NHTSA SAFETY RECALL

Safety Recall Notice #06V-019

KICKSTAND SPRING REPLACEMENT INSTRUCTIONS

Recall #06V-019

Spring comparison.

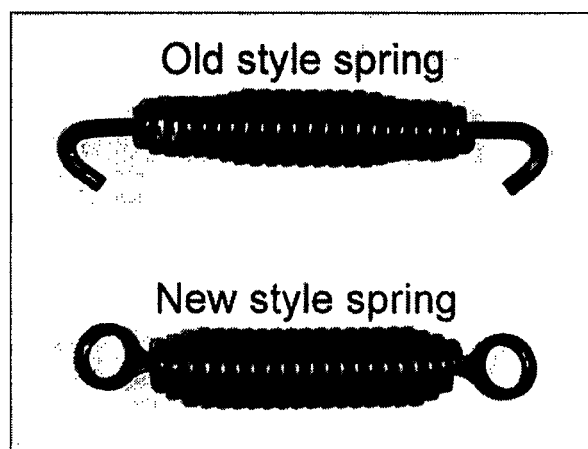
Old style kickstand springs can stretch and lose effectiveness.

Remove old style kickstand spring and replace with new style kickstand spring P/N 132-000029-01.
